PCN Number:	20201211001.1	PCN Date:	Jan. 15, 2021
Title:	Pin 1 Orientation change in carrier tape for TPS7A8400RGRT device		
Customer Contact:	PCN Manager	Dept:	Quality Services
Proposed 1st Ship Date:	Apr. 15, 2021	Estimated Sample Availability:	Date provided at sample request.
Change Type:			
<input type="checkbox"/> Assembly Site	<input type="checkbox"/> Assembly Process	<input type="checkbox"/> Assembly Materials	
<input type="checkbox"/> Design	<input type="checkbox"/> Electrical Specification	<input type="checkbox"/> Mechanical Specification	
<input type="checkbox"/> Test Site	<input checked="" type="checkbox"/> Packing/Shipping/Labeling	<input type="checkbox"/> Test Process	
<input type="checkbox"/> Wafer Bump Site	<input type="checkbox"/> Wafer Bump Material	<input type="checkbox"/> Wafer Bump Process	
<input type="checkbox"/> Wafer Fab Site	<input type="checkbox"/> Wafer Fab Materials	<input type="checkbox"/> Wafer Fab Process

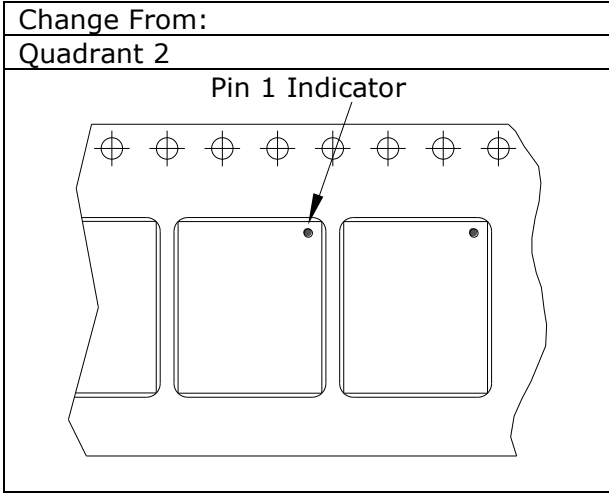
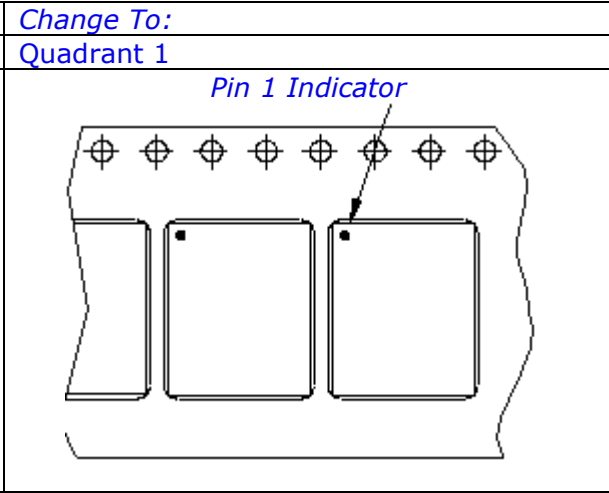
<input type="checkbox"/> Part number change		
PCN Details			
Description of Change:			
Pin 1 Orientation change for TPS7A8400RGRT device from Quadrant 2 to Quadrant 1. See diagrams below:			
Change From: Quadrant 2		Change To: Quadrant 1

Reason for Change:			
Standardize pin 1 orientation to match TPS7A8400RGRR device			
Anticipated impact on Form, Fit, Function, Quality or Reliability (positive / negative):			
None			
Anticipated impact on Material Declaration			
<input checked="" type="checkbox"/>	No Impact to the Material Declaration	<input type="checkbox"/>	Material Declarations or Product Content reports are driven from production data and will be available following the production release. Upon production release the revised reports can be obtained from the TI ECO website .
Changes to product identification resulting from this PCN:			
None			
Product Affected:			
TPS7A8400RGRT
